VIRGINIA ELECTRIC AND POWER COMPANY
RICHMOND, VIRGINIA 23261

November 7, 2022

VIRGINIA ELECTRIC AND POWER COMPANY (DOMINION ENERGY VIRGINIA)
NORTH ANNA POWER STATION UNITS 1 AND 2
SURRY POWER STATION UNITS 1 AND 2
PROPOSED LICENSE AMENDMENT REQUEST TO
REVISE EMERGENCY PLAN STAFF AUGMENTATION TIMES

FIGURE 5.35-a

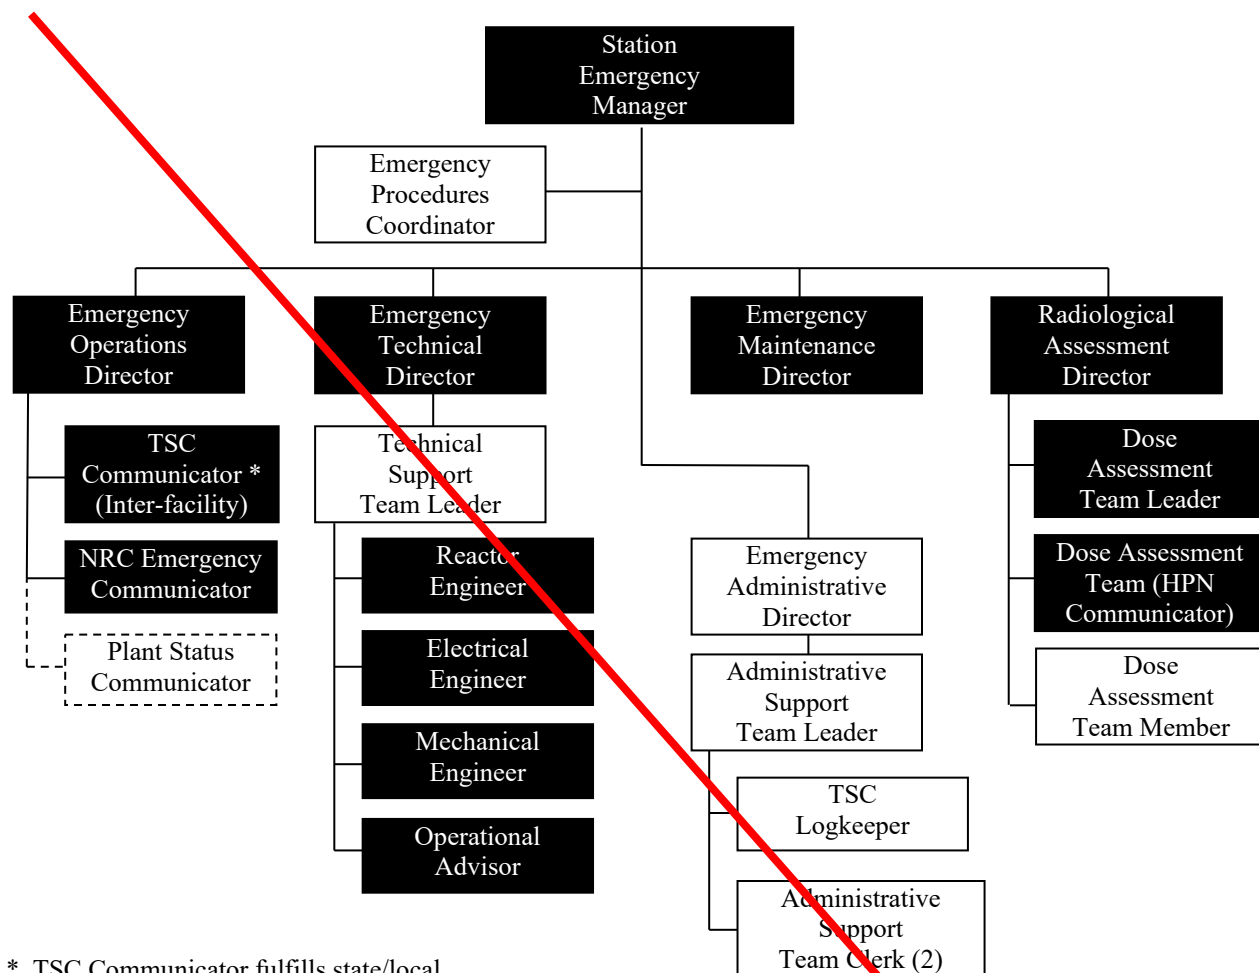
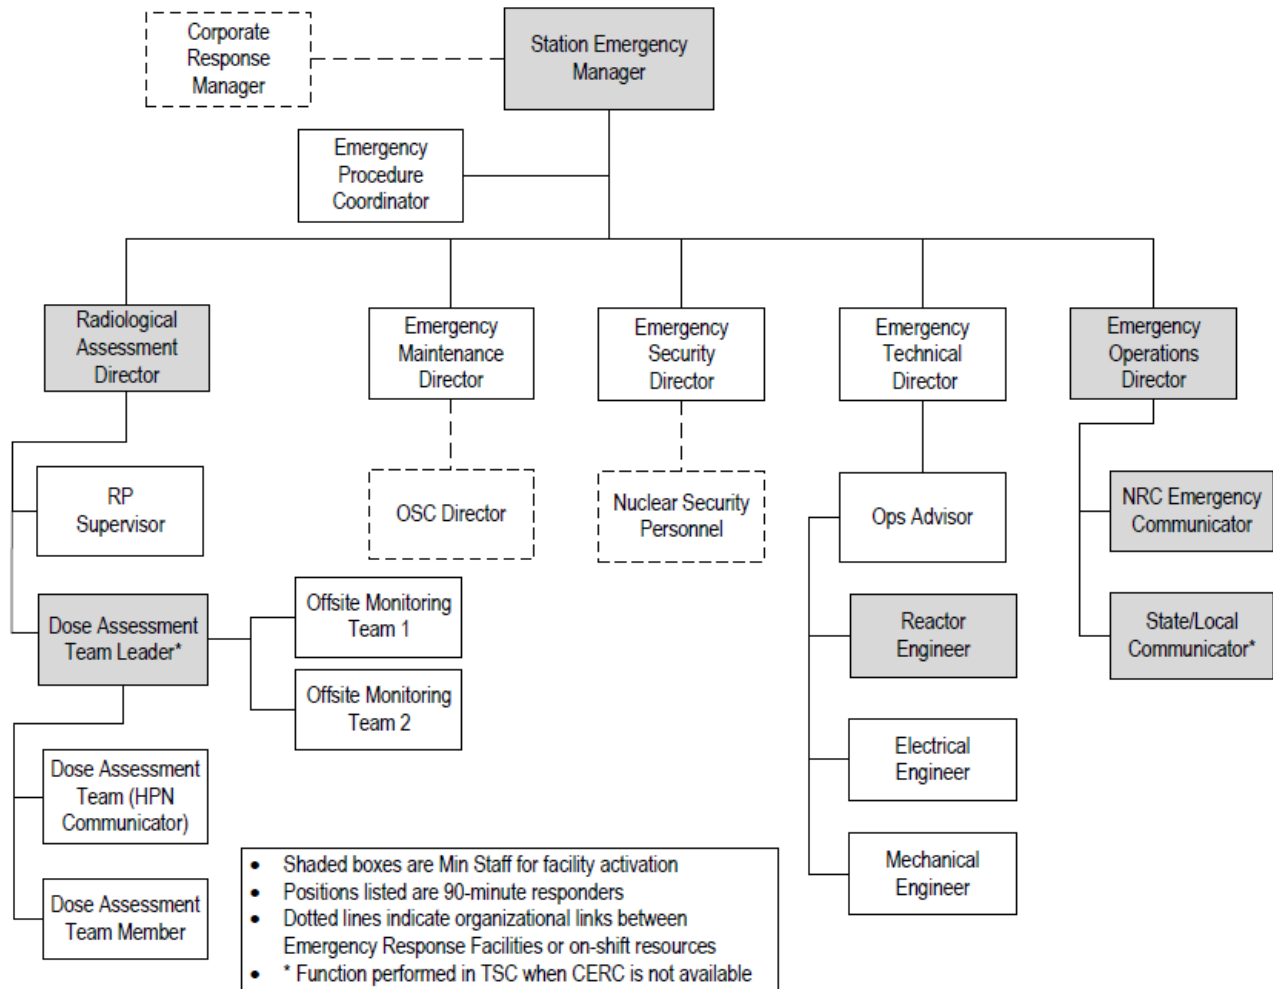
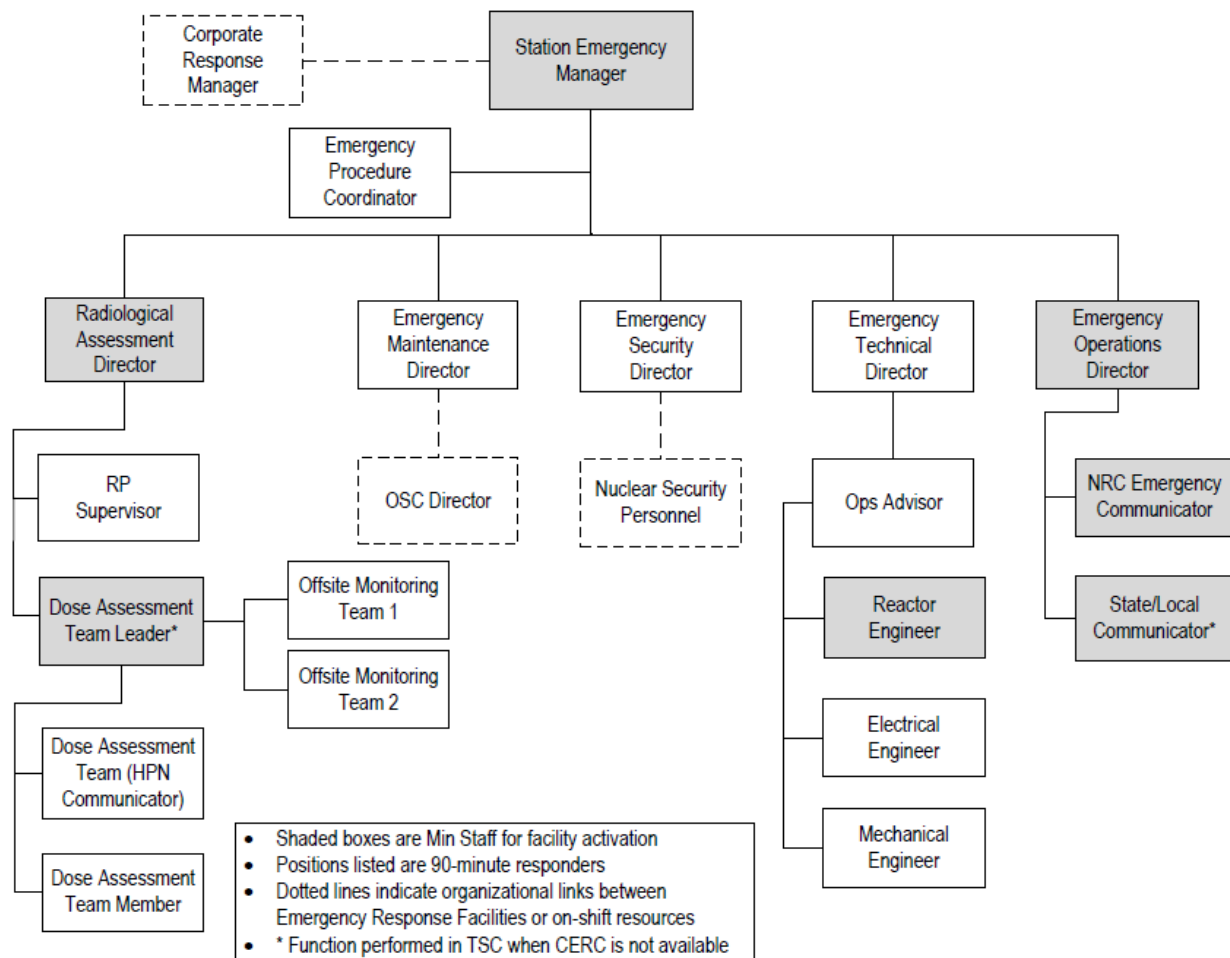
- tt. Figure 5.5.a, "Technical Support Center Organization," renumbered section and revised to reflect proposed staffing and positions required for facility activation.

FIGURE 5.45.b

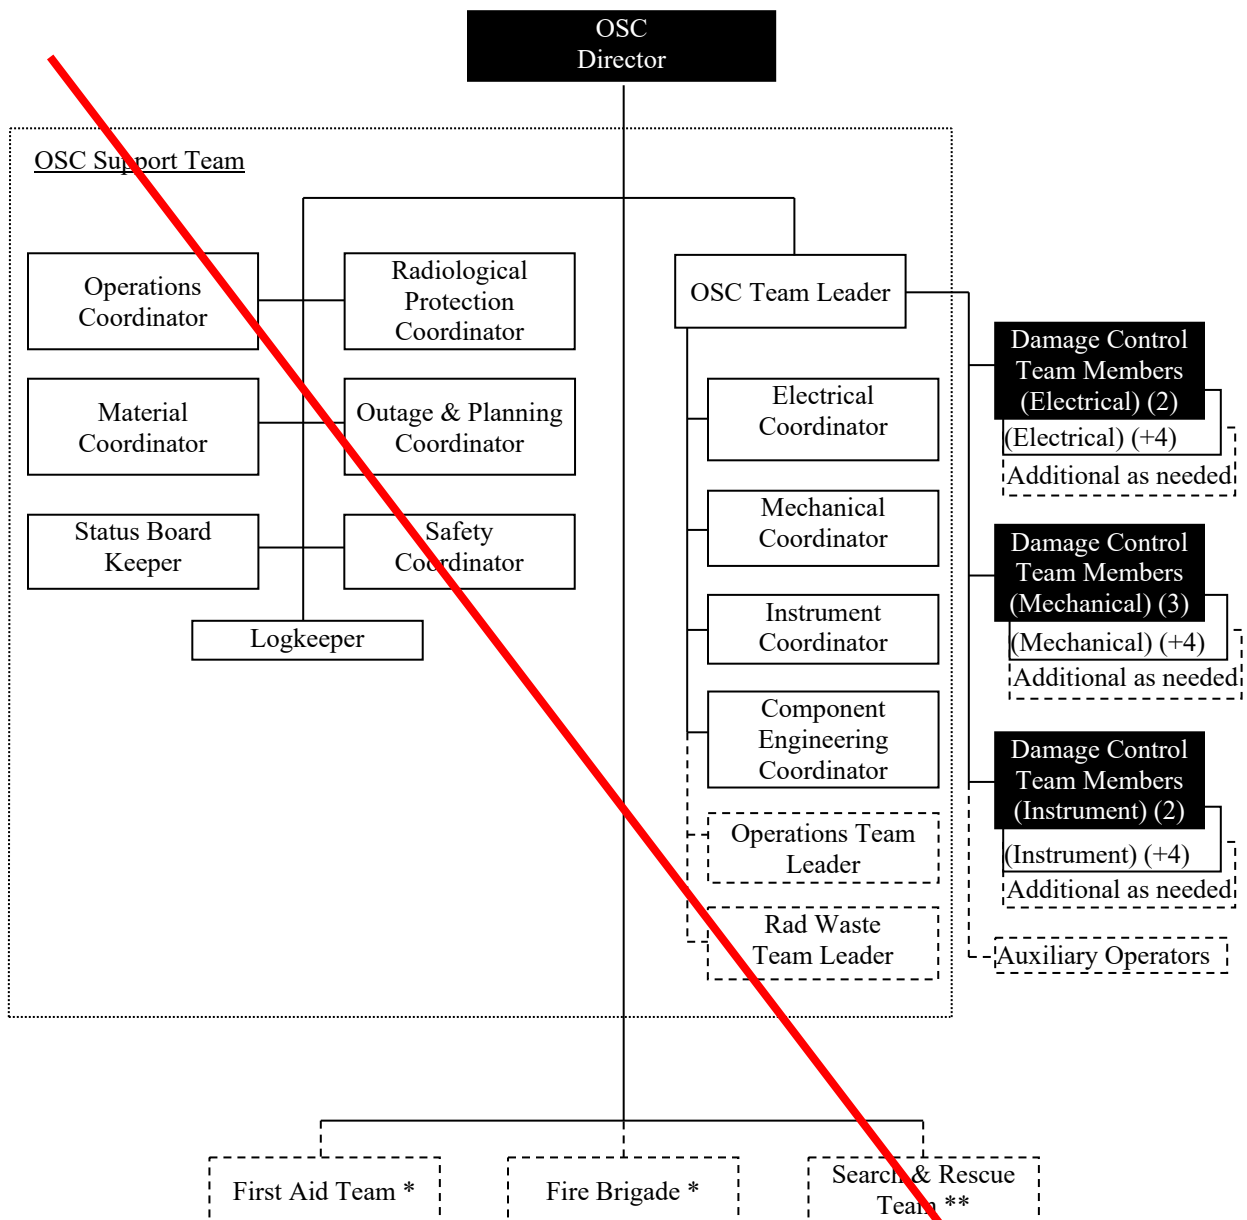
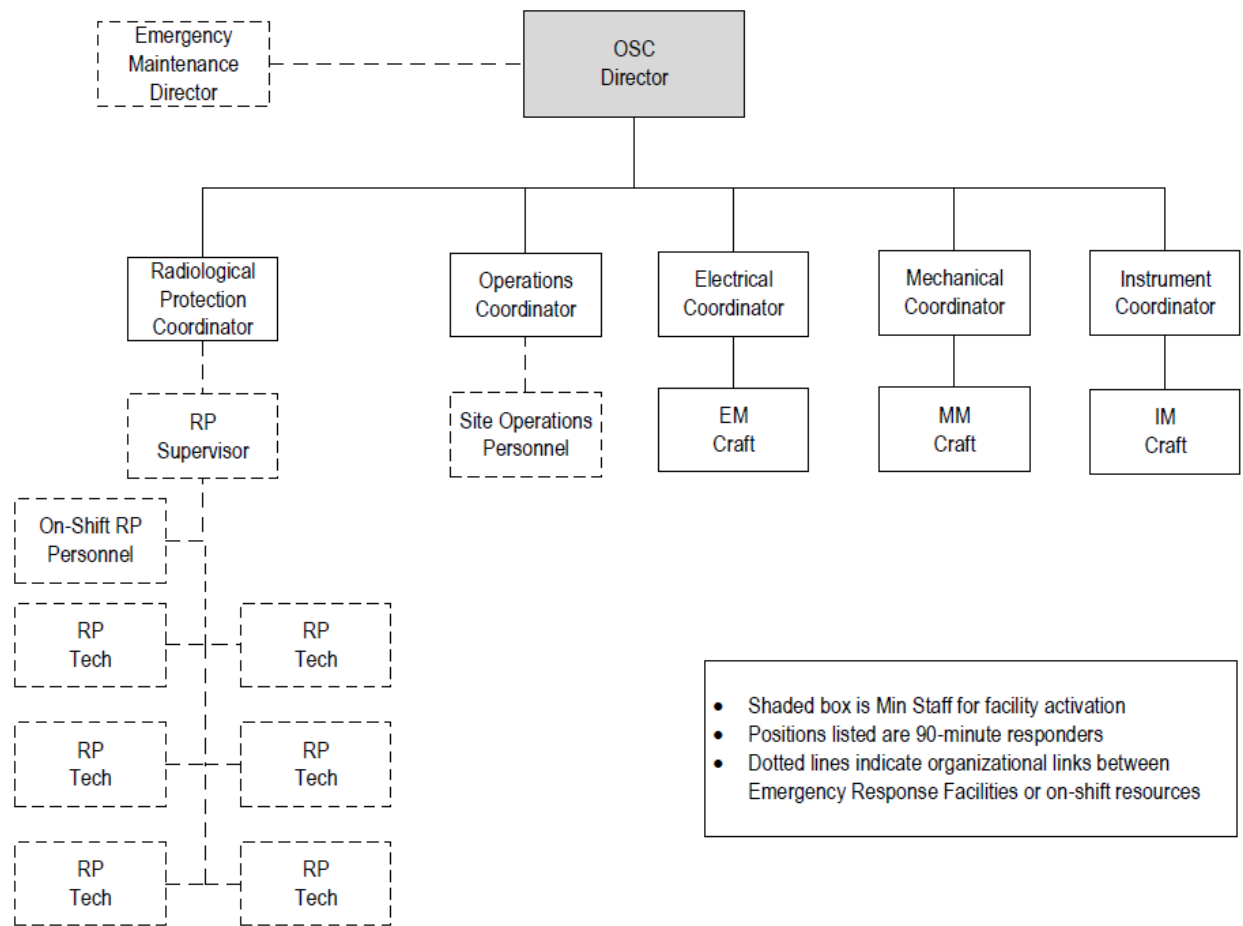
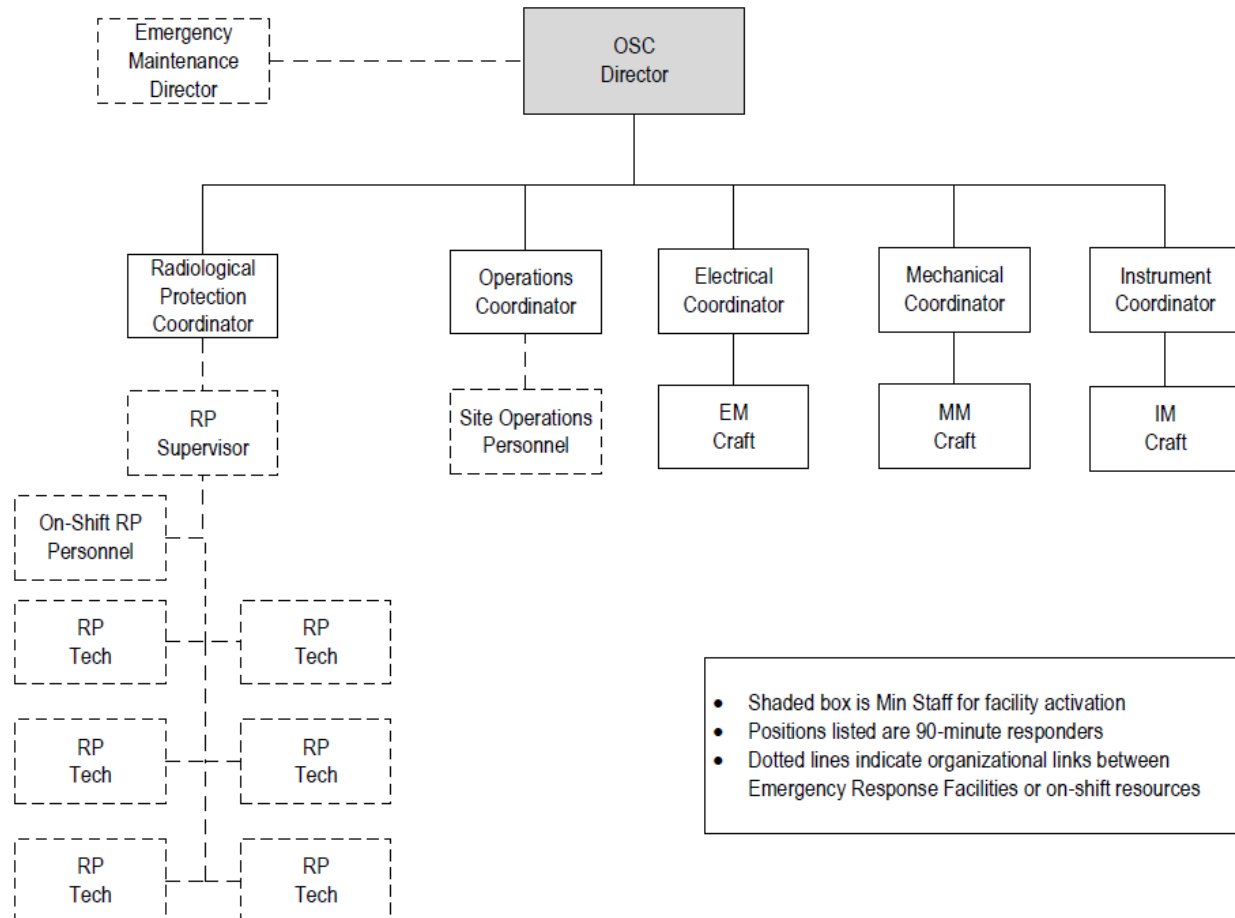
- uu. Figure 5.5.b, "Operational Support Center Organization," renumbered section and revised to reflect proposed staffing and positions required for facility activation.

RADIATION PROTECTION ORGANIZATION
FIGURE 5.5.e

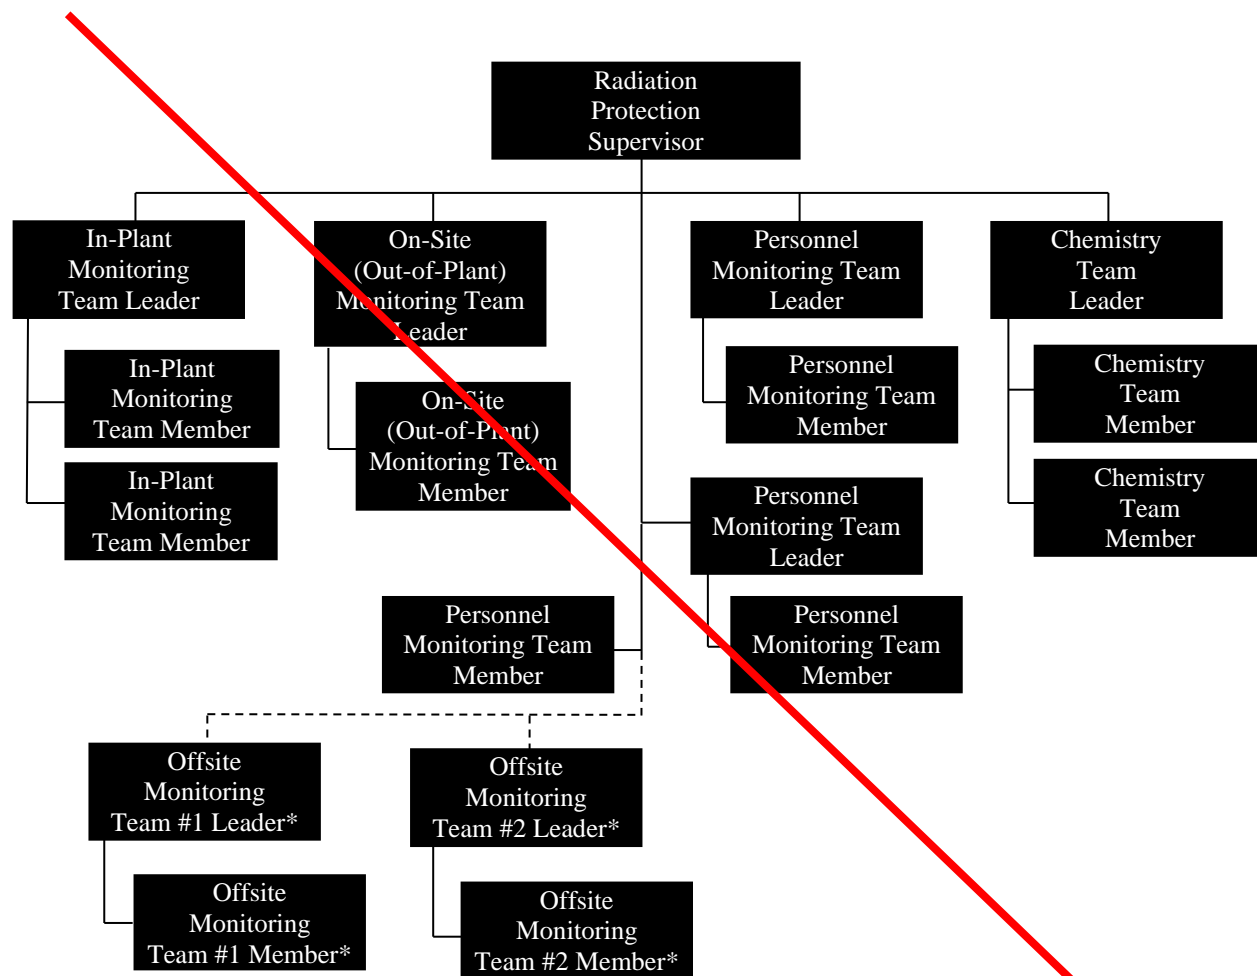
- vv. Figure 5.5.c, "Radiation Protection Organization," deleted figure. Radiological Protection (RP) responders incorporated into TSC, OSC, and CERC figures to better reflect response in each facility.
